Office Action Summary	Application No. 10/565,893	Applicant(s) RYMER ET AL.	
	Examiner DANIEL T. SHARPE	Art Unit 3752

DETAILED ACTION

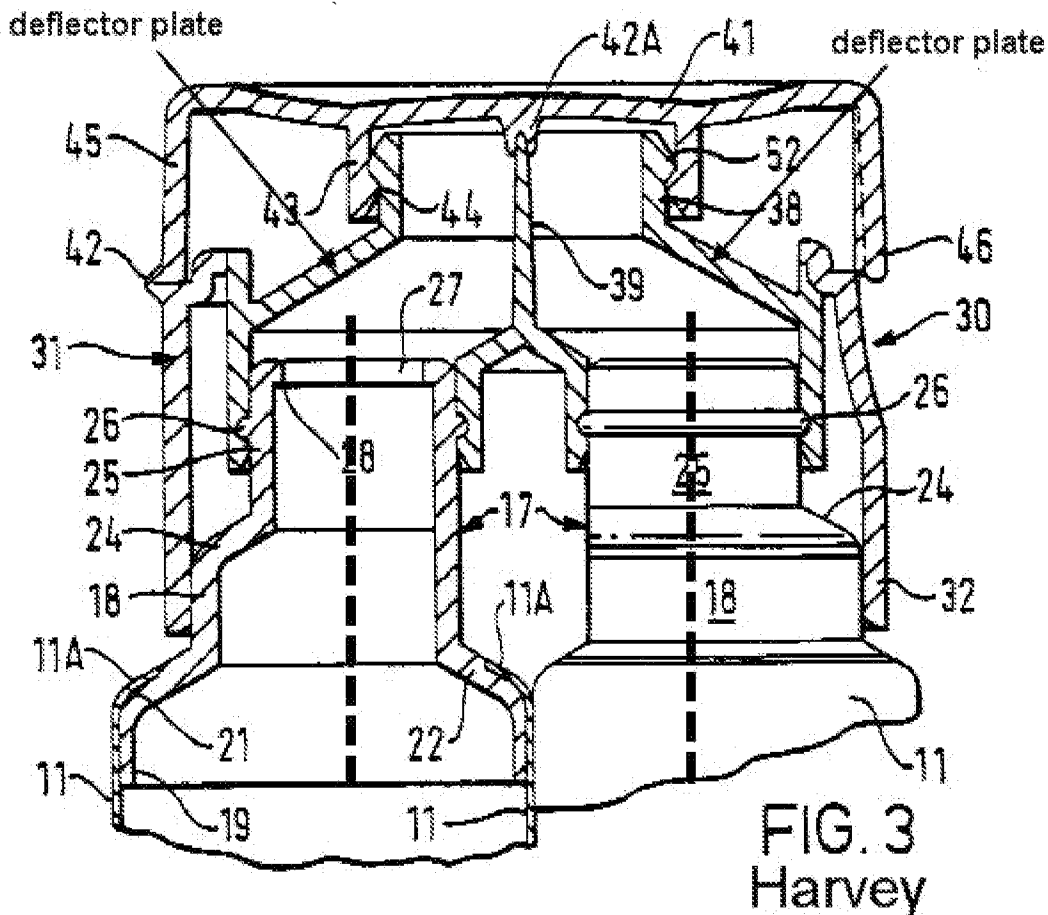
Regarding claim 1: Harvey discloses a bottle having two reservoirs (11), a separate passageway from each reservoir, each passageway opening to the atmosphere (when the cap is removed as in figure 5), a deflector plate (39) between the openings, in contact with at least one of the liquid streams, the openings arranged so

that the liquid streams are caused to be deflected towards the other stream causing the streams to mix once they have passed the deflector plate.

Regarding claim 2: The passageways are side by side.

Regarding claim 3: A single deflector plate deflects liquid from both passageways.

Regarding claim 5: Each passageway has its own deflector plate as illustrated in examiner generated figure below.

Regarding claim 7: The two passageways are substantially parallel as shown by the dotted line in the examiner generated figure below.
